TOPIC: PC 23-004: the Flats & the Lofts of West Village: PUD Site Plan Review

Subject: PC 23-004: The Flats & The Lofts of West Village: PUD Site Plan, Review #2

Re: West Village PUD
Final PUD Review #2 – revised 8/30/23
NFE Job No. M900

1 LOWER LEVEL FLOOR PLAN
SCALE: 1/8"=1'-0"

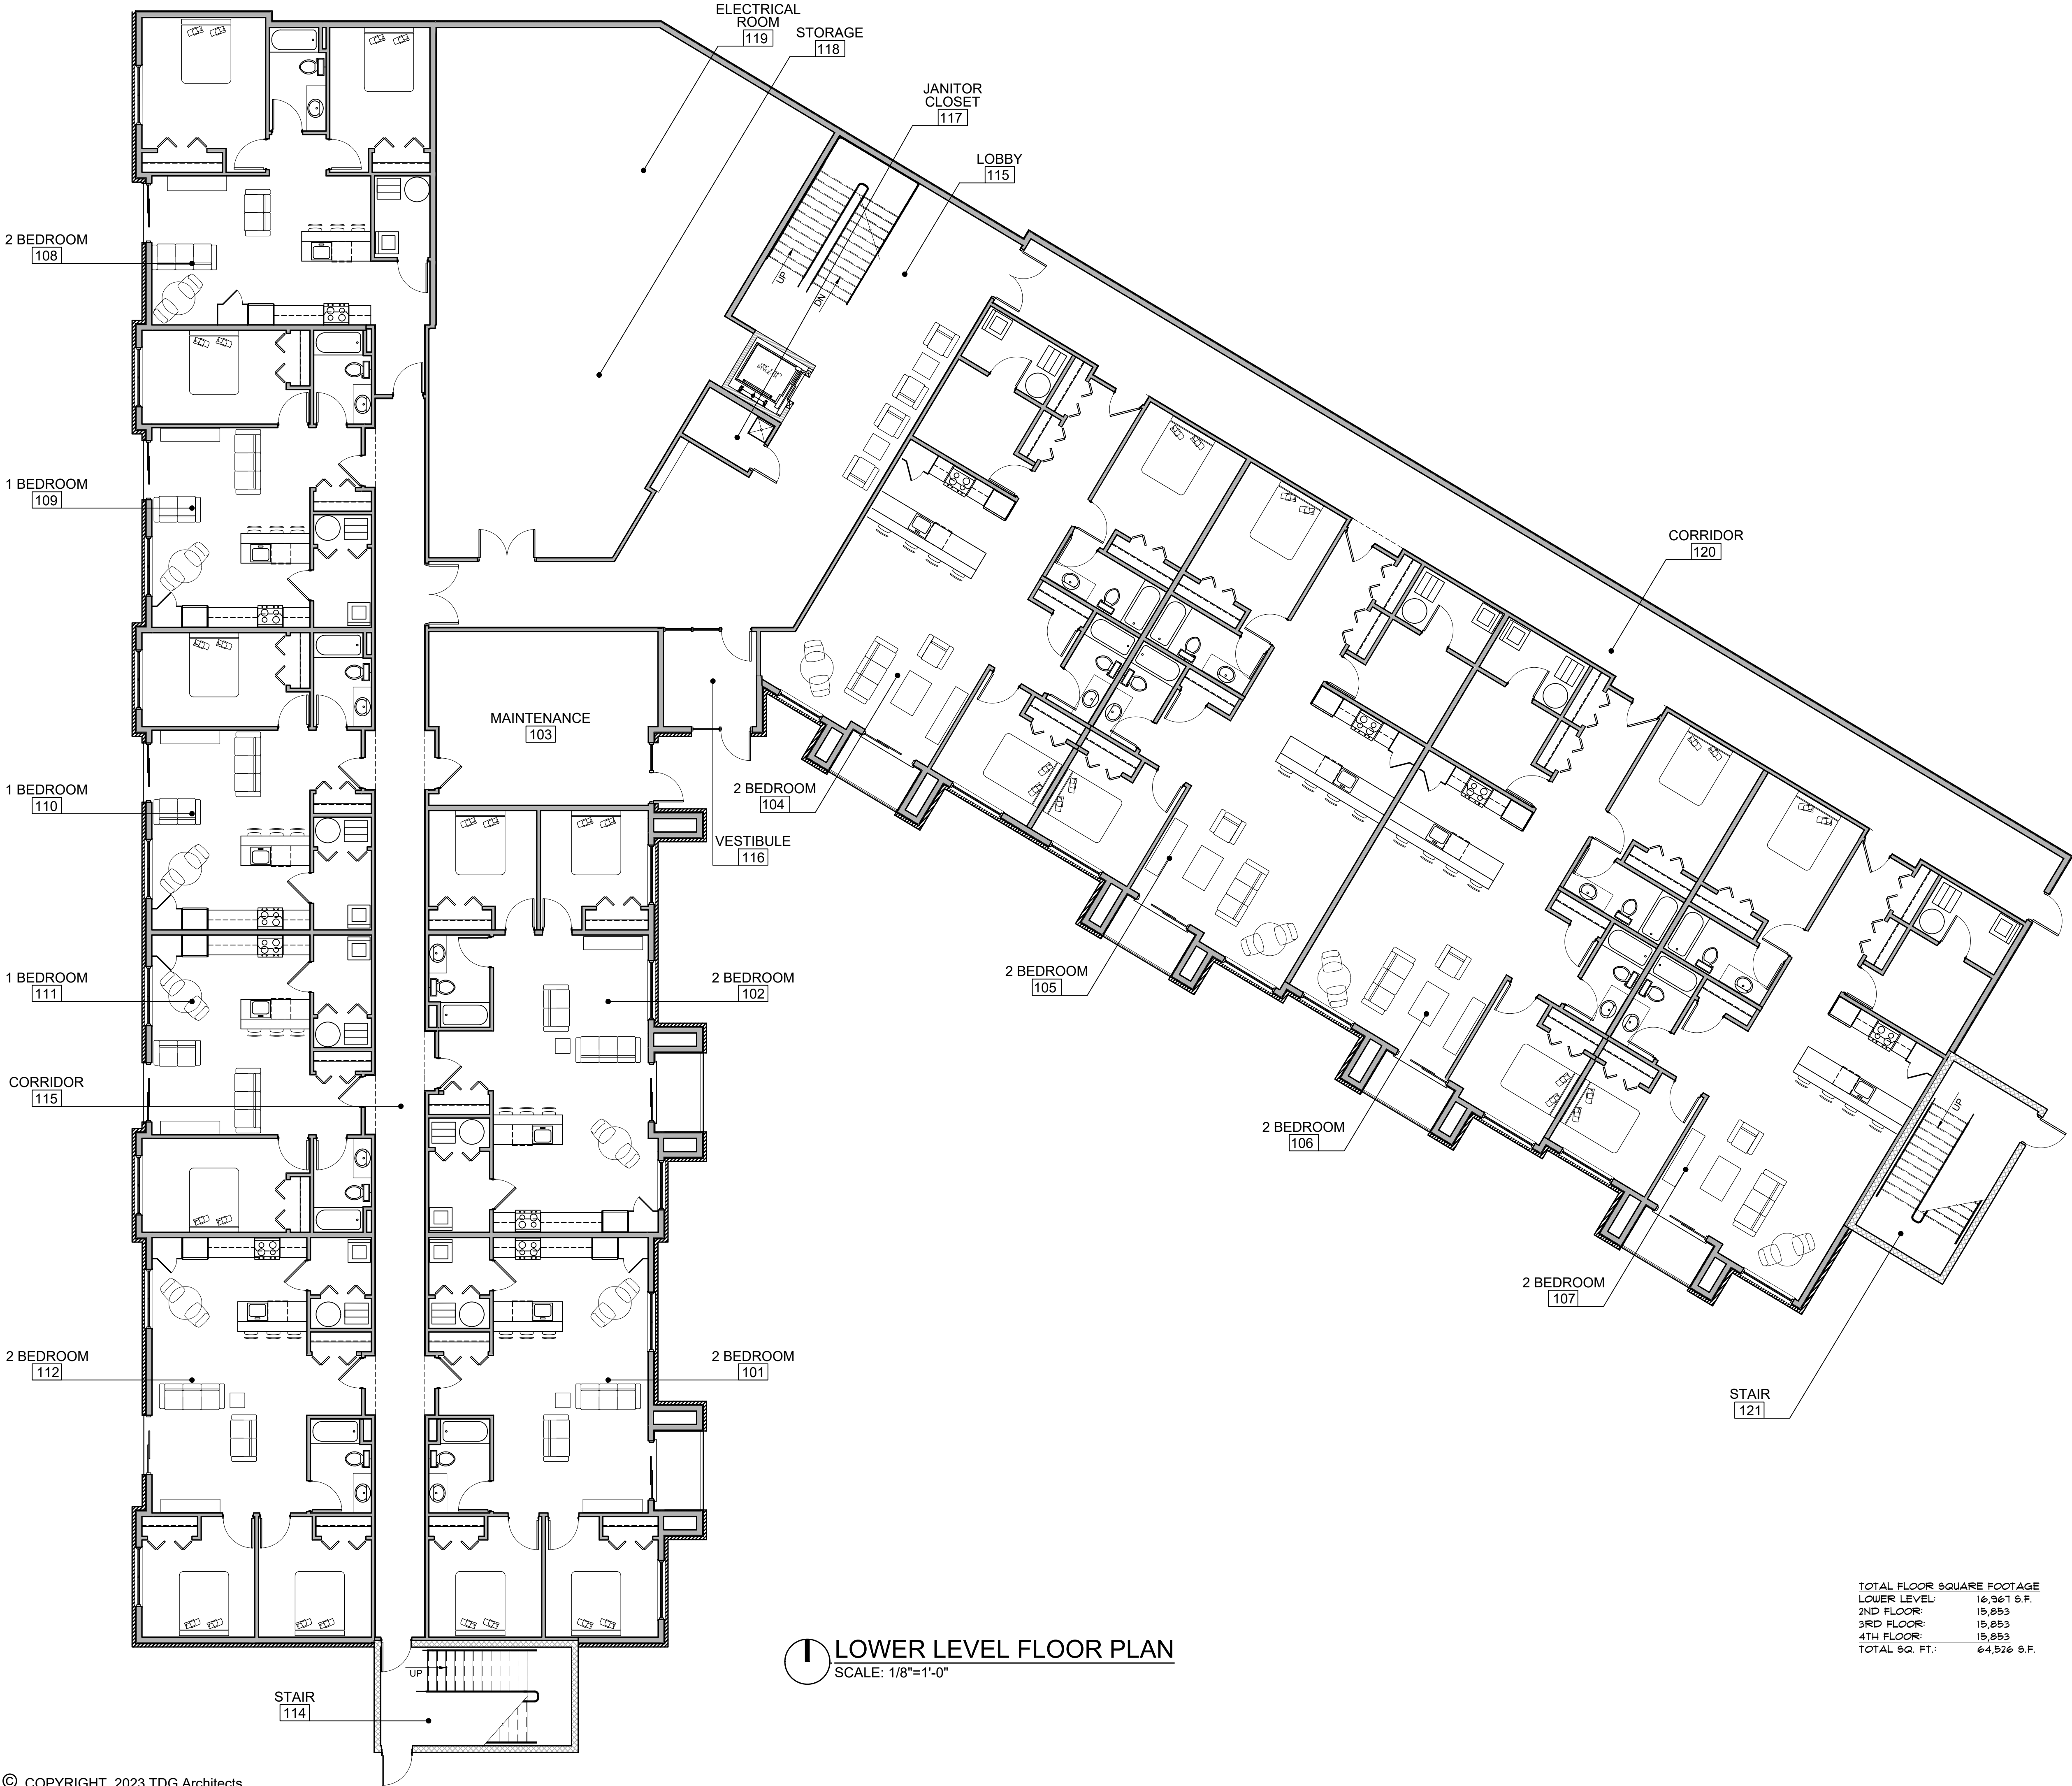
There is a discrepancy between unit sizes shown on the unit information tables for the Flats and what is shown in the floor plans (Sheet A 101); for instance, the lower-level floor plan shows four (4) 3-bedroom units but these are noted as 2-bedroom units in the table. This discrepancy must be addressed. Further, several bedrooms within both buildings are proposed without windows – this would need to be rectified prior to submitting building permits.
